DEVELOPMENT OF DRAFT CONSTRUCTION SAFETY STANDARDS FOR EXCAVATIONS

DEVELOPMENT OF DRAFT CONSTRUCTION SAFETY STANDARDS FOR EXCAVATIONS

May 1983

NBSIR 83-2693

Figure 1. Effects of nearby foundation loads that must be determined by an engineer

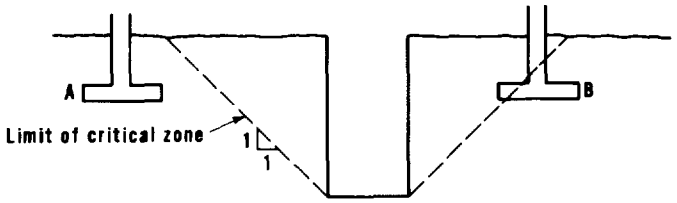
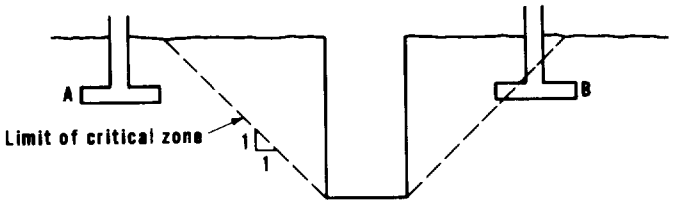
(b)(1) It was noted that in some regions there are local practices which have a long track record of successful application and an excellent safety record (see memoranda and letters on Wisconsin workshop). These practices do not always comply with the proposed Standard Practice (for instance, the struts in the Wisconsin practice cannot support the weight of a man - per F. Yokel memo). Introduction of the Standard Practice in such locations may actually increase accidents because workers have to be re-trained.

Established regional practices can be used in lieu of the Standard Practice if they are approved by local authorities and have a proven record of at least 5 years of successful application. Such practices are subject to review and revocation if a serious accident occurs. Any change in such regional practices shall comply with the Standard Practice.

The provision that a change in an estalbished regional practice must comply with the standard practice will safeguard against lateral load increases and failures, resulting from the replacement of shoring members used in the established practice by members made of different materials which may have the same working strength as the original member, but differ- stiffnesses and safety margins.

Figure 2. Allowable configurations of sloped excavations (cases II, III, and IV are for short-term excavations)

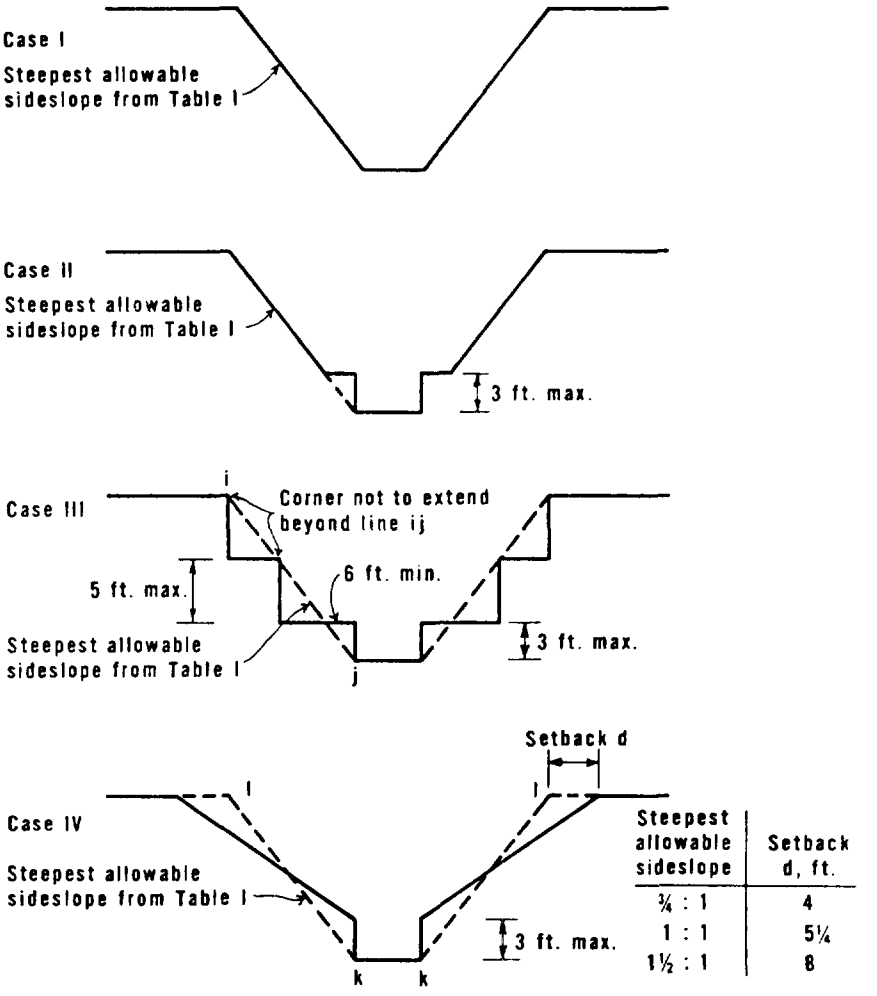
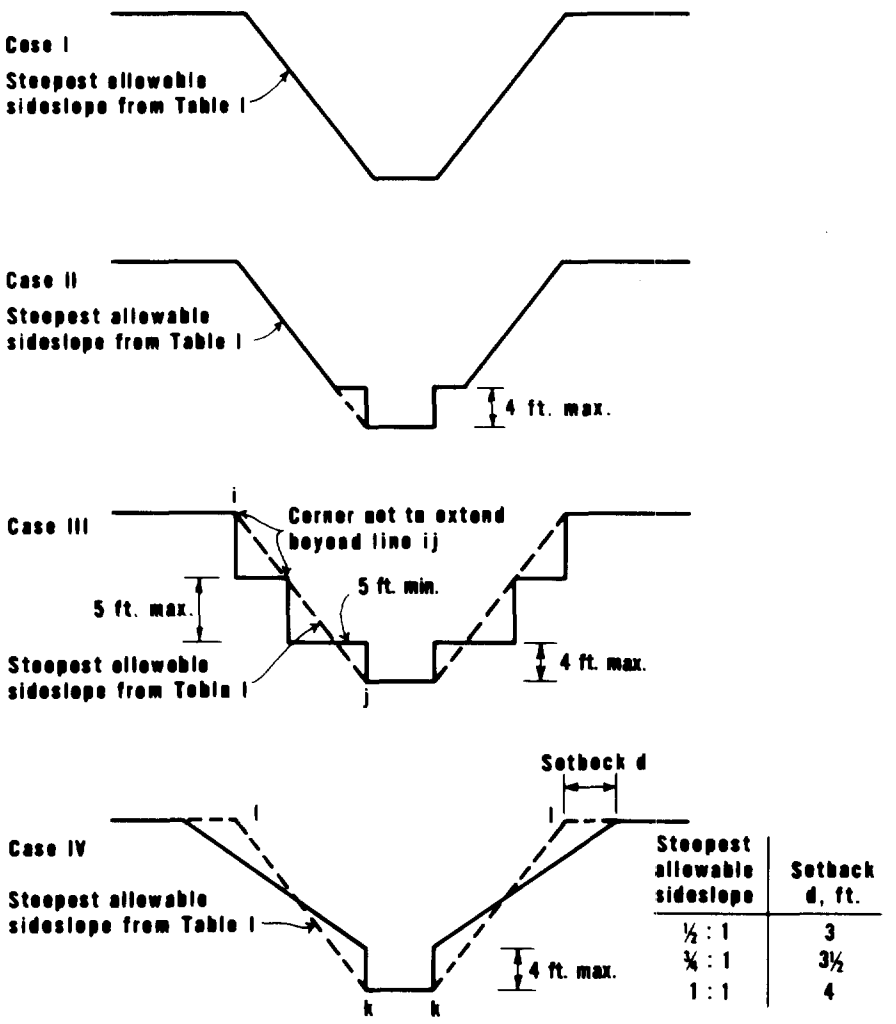
(3) Sloped Excavations Sloped excavations shall not have sideslopes steeper than those stipulated in table 1. If there is any indication of general or local instability, slopes shall be cut back to the stable slope. The slope configurations shown in figure 2 can be used.	(3) See comments on table 1 and figure 2.
Figure 2--refer to page 24 for magnified print of figure 2.	Figure 2 Different opinions were expressed regarding the bank next to the work area. Many contractors expressed the opinion that the bank should be increased to 4 ft (Dallas and Atlanta workshops, Kentucky AGC and others). In the Dallas workshop, it was suggested by some contractors to increase the bank to 5 ft (workshop memo). AFL-CIO recommended to leave the allowable height at 3 ft. The point was made that if a large pipe is laid it would provide workers protection against collapse of the bank next to the work area. AFL-CIO objected to case IV as too complicated for regulation--recommended to make it advisory.

(b/ ...Slopes shall be cut back to the stable (flatter) slope? Change Table 1 to use 3/4:1 maximum slope as the only limitation?)

RECOMMENDATIONS/SUGGESTIONS	COMMENTARY
(2) NO CHANGE RECOMMENDED	
Refer to page 23 for magnified print of table 1.	
(3) NO CHANGE RECOMMENDED	
Figure 2--Refer to page 25 for magnified print of figure 2.	Figure 2 The revised sketch is a suggestion rather than a recommendation. It is recommended that industry try to reach agreement on the height of the allowable bank. Reasons for increasing the bank to 4 ft would be that the safety risk is not substantially increeased, while accommodating pipe bedding specifications presently used by many municipalities, etc. The suggested scheme would accommodate most specifications, while the original scheme would conflict with some. Frequent situations of conflict between excavation safety regulations and job specifications could undermine the effectiveness of the regulations.

It is obvious from the workshop discussions that the maximum allowable slopes are too severe for many regions. Thus, these sloping requirements are relaxed. To offset possible hazards resulting from this relaxation, footnote b) was modified to explicitly charge the competent person on the job with the responsibility of selecting a safe slope. This approach is also in line with the ASFE comment that stipulates slopes cannot be used "blindly."

Figure 3. Determination of Adjusted Depth

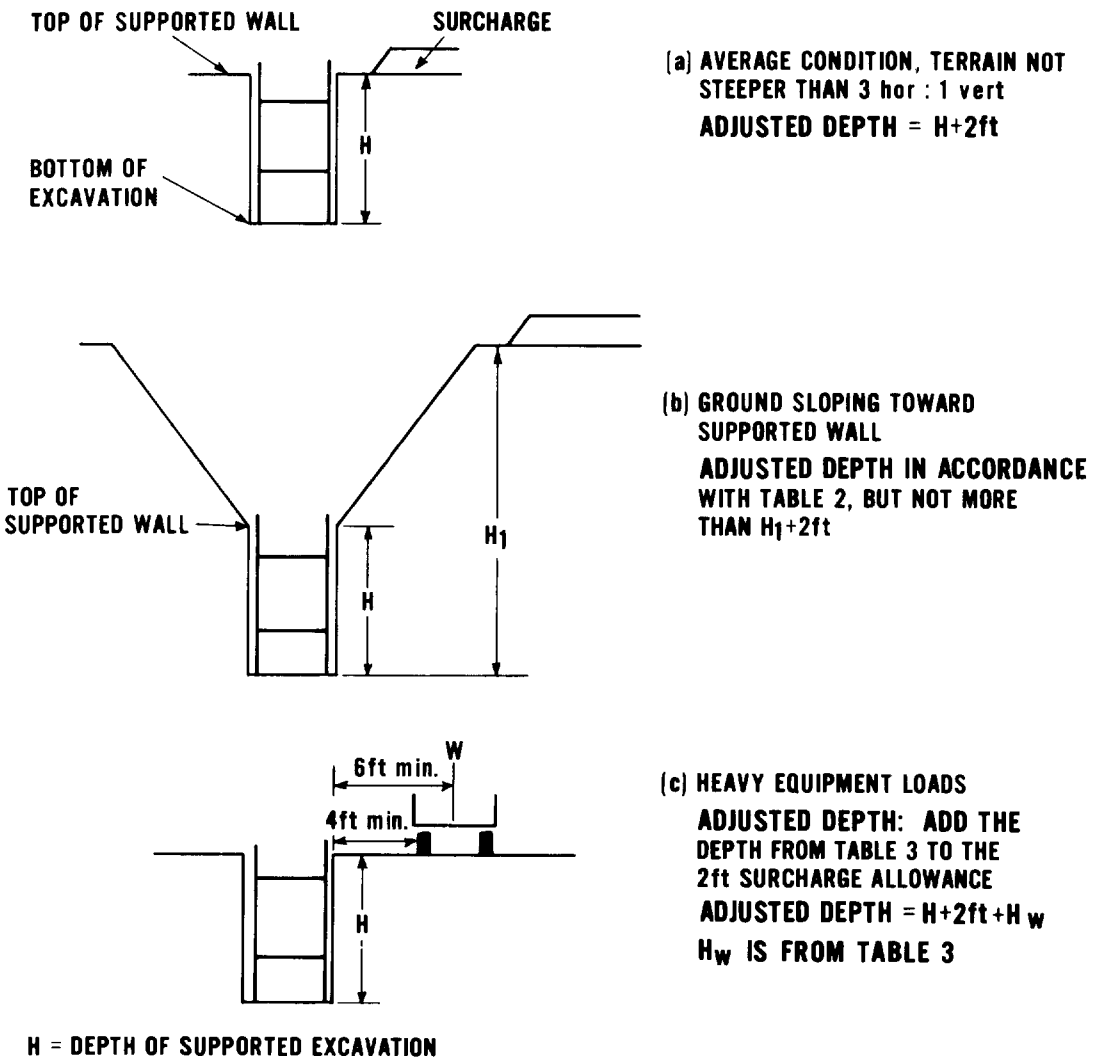
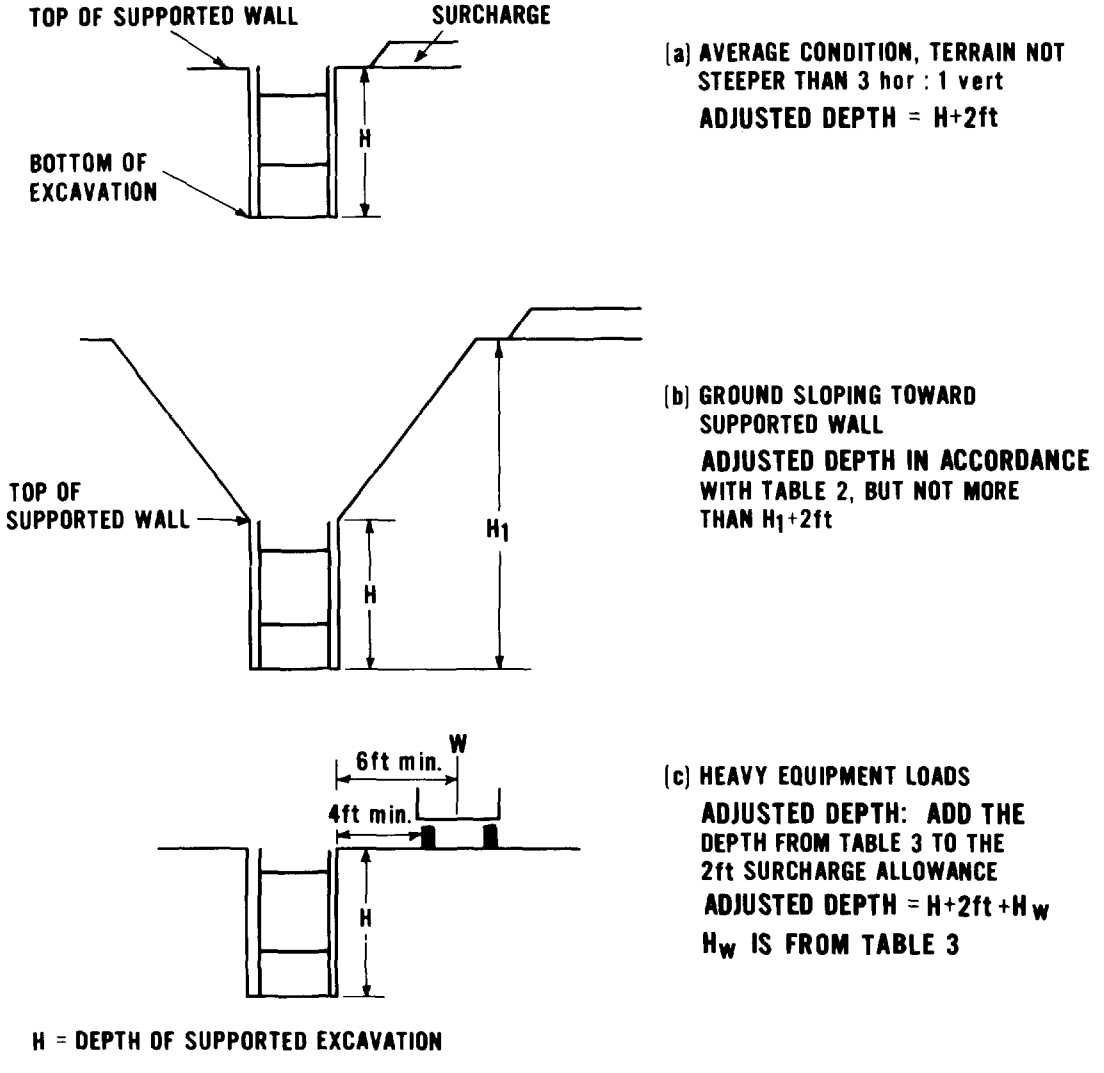
TEXT SUBMITTED TO WORKSHOP	COMMENTS
TABLES 2 and 3 (Refer to appendix)	Tables 2 and 3 SEE COMMENTS ON 4(i)
Figure 3	Figure 3 It was suggested to eliminate the protrusion of shoring, as this is many times not used, and frequently not desirable as a means of protection against rolling or sliding objects (Bradberry).

RECOMMENDATIONS/SUGGESTIONS	COMMENTARY
(4)(i) NO CHANGE RECOMMENDED	(4)(i) Even though b. and c. require some skill, their application should not be too difficult for a competent person to handle. The alternative of a need to consult a qualified person who is not on the job is even less attractive. The AFL-CIO suggestion of increasing the surcharge requirement in a., and in return eliminating b. and c., would mean in practice that in case b., a backslope of maximum 4 ft. height (H_1 in figure 3b = 4 + 4 ft) could be allowed, and equipment of maximum 20,000 lb. With higher backslope and heavier equipment, an engineer (qualified person) would have to be consulted. If this is acceptable, OSHA could go that route.

TABLES 2 and 3 NO CHANGE RECOMMENDED

Figure 2: Allowable Configurations of Sloped Excavations (Cases II, III and IV are for short-term excavations)

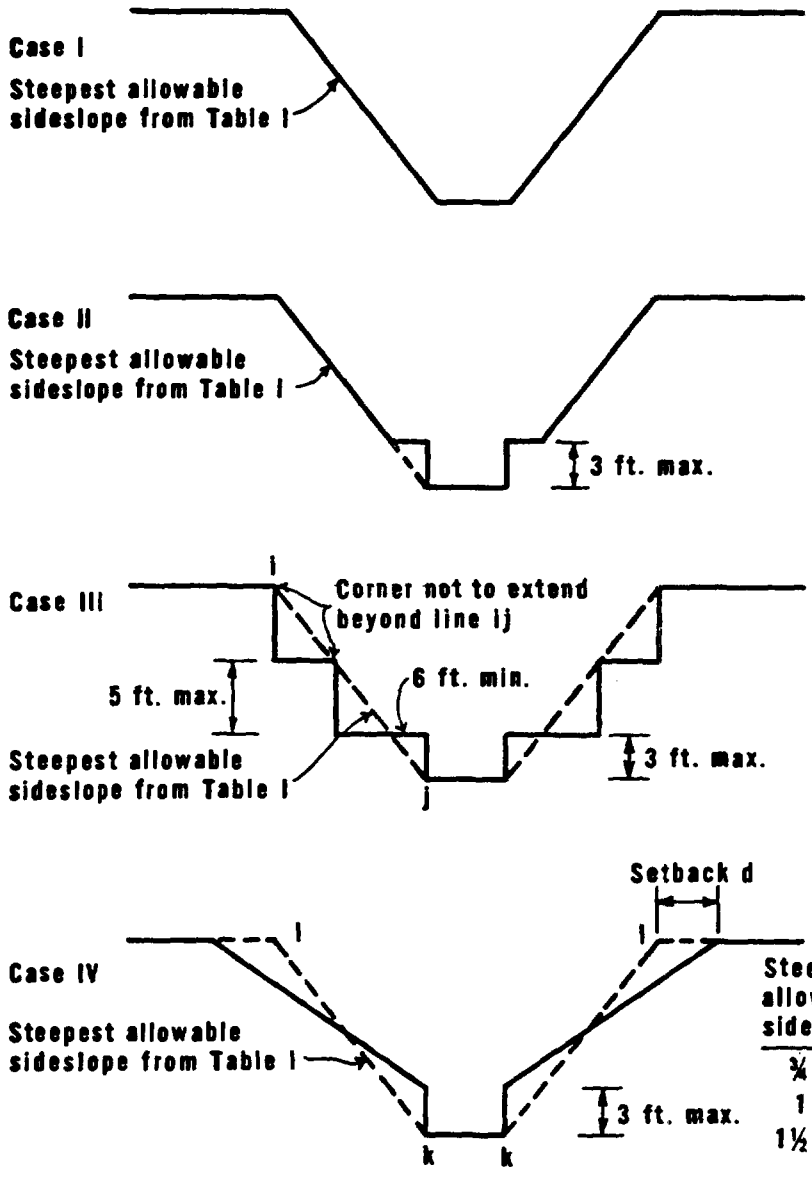
6. Page 12. Figure 2: Should the allowable bank next to the work area in Cases II, III and IV be increased to 4 ft? Should "Case IV" be limited to excavation by trenching machines?

(b/ ...Slopes shall be cut back to the stable (flatter) slope? Change Table 1 to use 3/4:1 maximum slope as the only limitation?)
